**CPC Red House Farm Solar Power Station – Planning Application [P24/V2489/FUL](#)
Response by Cumnor Parish Council v1 07/04/2025**

1. Cumnor Parish Council (CPC) wishes to object to this resubmitted planning application for a solar power station.

Google Earth Pro path from CNP Important View 3 to Important View 1 – source CPC

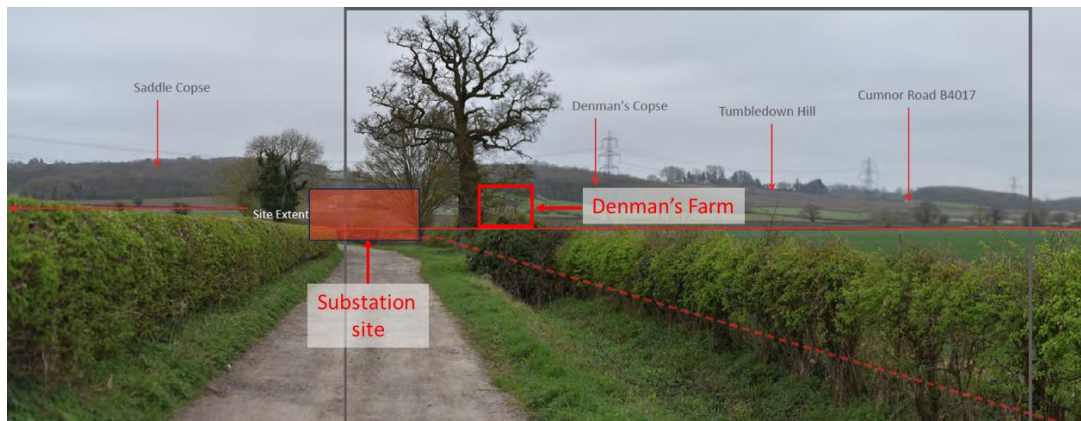
As just one example, CPC analysis of the Google Earth Pro ‘path’ from CNP Important View 3 to Important View 1 (see below) shows how the proposed site sits some 34m below Important View 3 and 30m below Important View 1 – the site being visible in the foreground from both.

Similar visibility is afforded from Important View 16 and Important View 23.

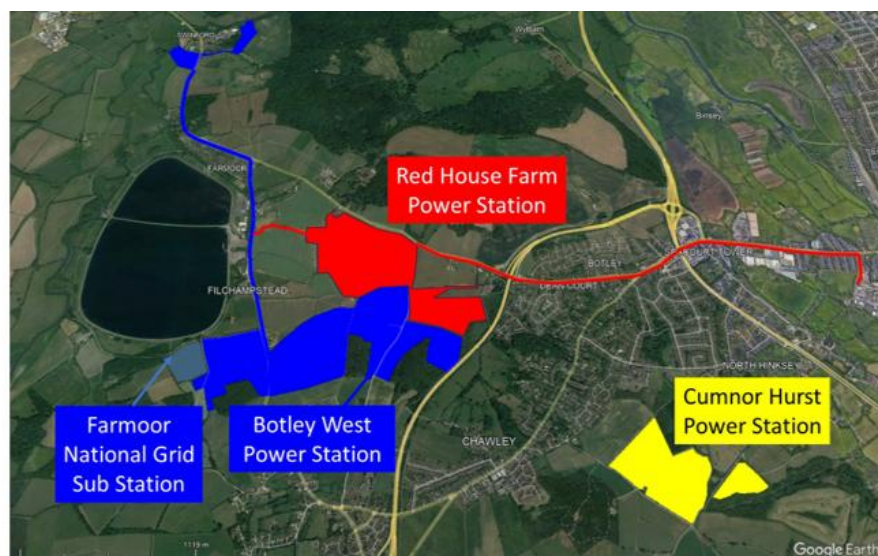
The 'reverse' view is also shown by the applicant (page 94 of Appendix 7.1) as a photo with a few lines superimposed (below).

Again, CPC (below) shows instead a visualisation, as requested by VWHDC, showing the extent of the panels and the 2x substations.

4 Modules in Landscape at 20° tilt
Scale 1:50 @A3

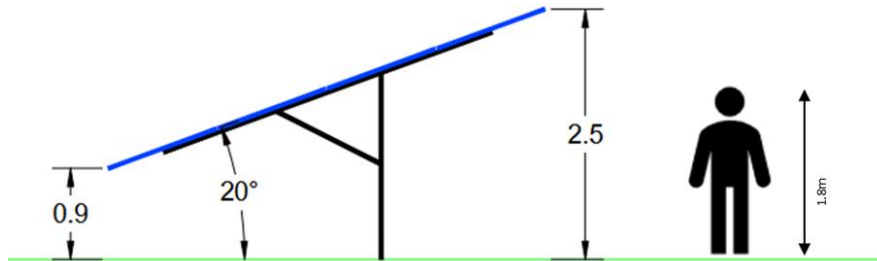
CPC visualisation showing how viewpoint of a 1.8m tall person will be impacted by 2.5m high panels

Figure 5. Flood Zone 3 Extents Overlain with the Site Plan

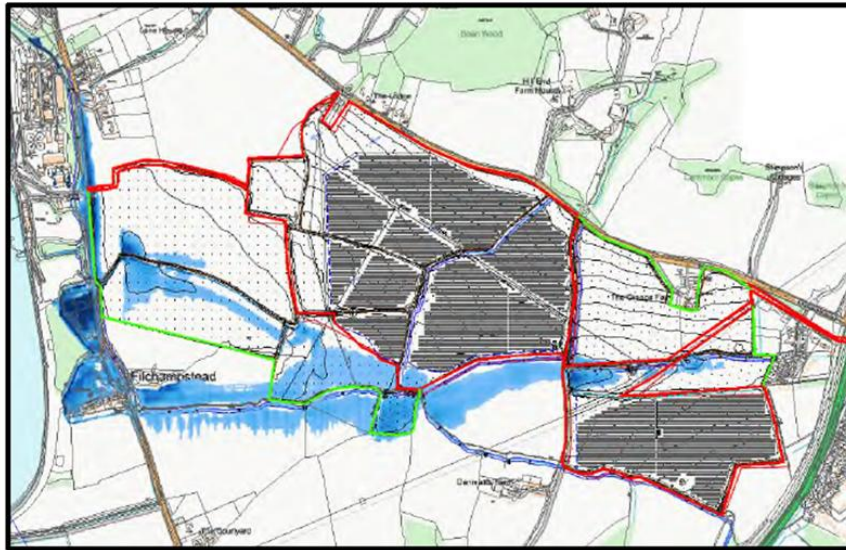
following on from the modelling, the planning layout has been amended to remove any infrastructure within areas noted to be within Flood Zone 3 (the 1 in 100yr flood event with climate change).

And refers to Figure 5 below:

Unfortunately for the applicant the flood risk is not as benign as portrayed.

Figure 5. Flood Zone 3 Extents Overlain with the Site Plan

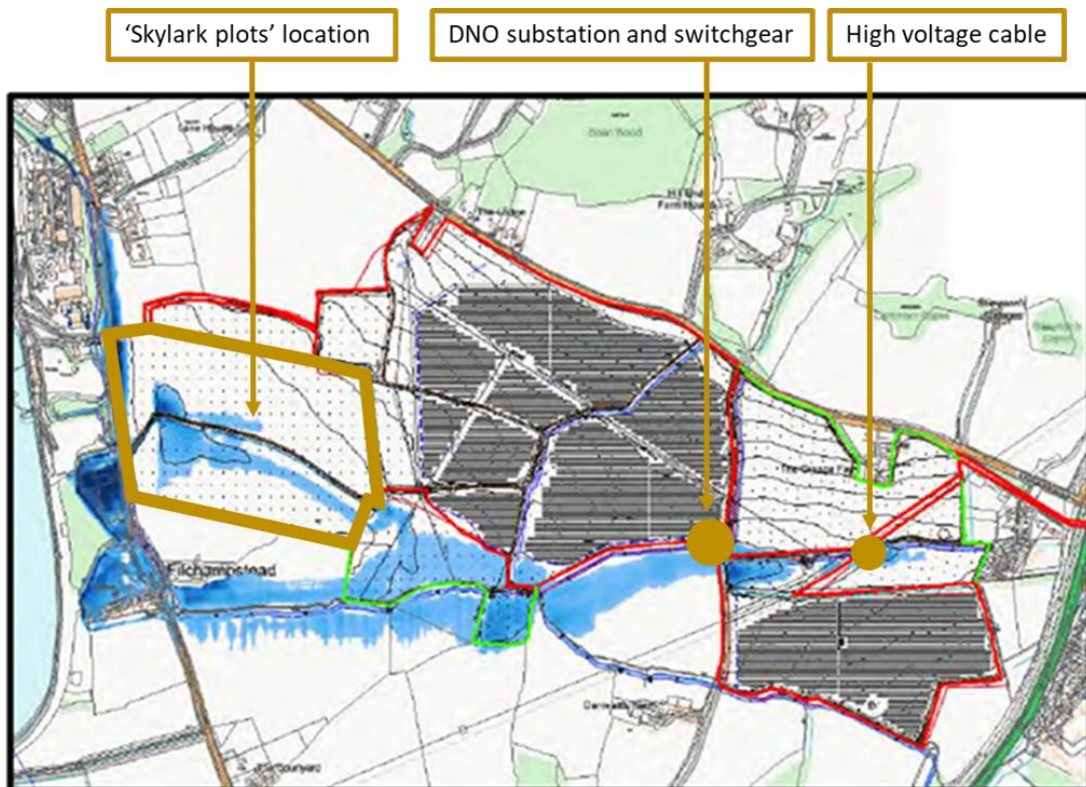
Overlaying the location of the DNO substation, the high voltage supply cables and the proposed skylark plots onto Figure 5, show all are within the 1 in 100 year flood risk zone.

But even the applicant's flawed theoretical assessment, bringing with it the prospect of flooding of a permanently installed high voltage electricity substation, HV cables and a proposed skylark habitat, doesn't fully encompass the flood risk.

Figure 4 Site Context Plan pp9 of 3377 ES Appendix 7.1 pages 1-63.pdf showing proposed cable route

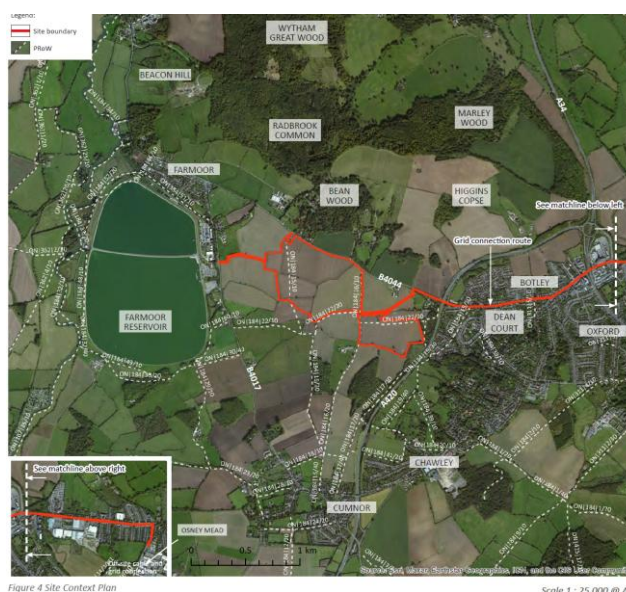
- 8 **Highways and Traffic Matters:** CPC is alarmed to read that the developer plans to lay the high voltage cable connecting the power station to the Osney Island substation within the carriageway over a distance of 5+ km along the Eynsham Road (B4044), the West Way and the Botley Road, which will inevitably give rise to that road being at least partially closed for c. 40 weeks (see ES para 4.12, 4.35 and 4.37¹³).
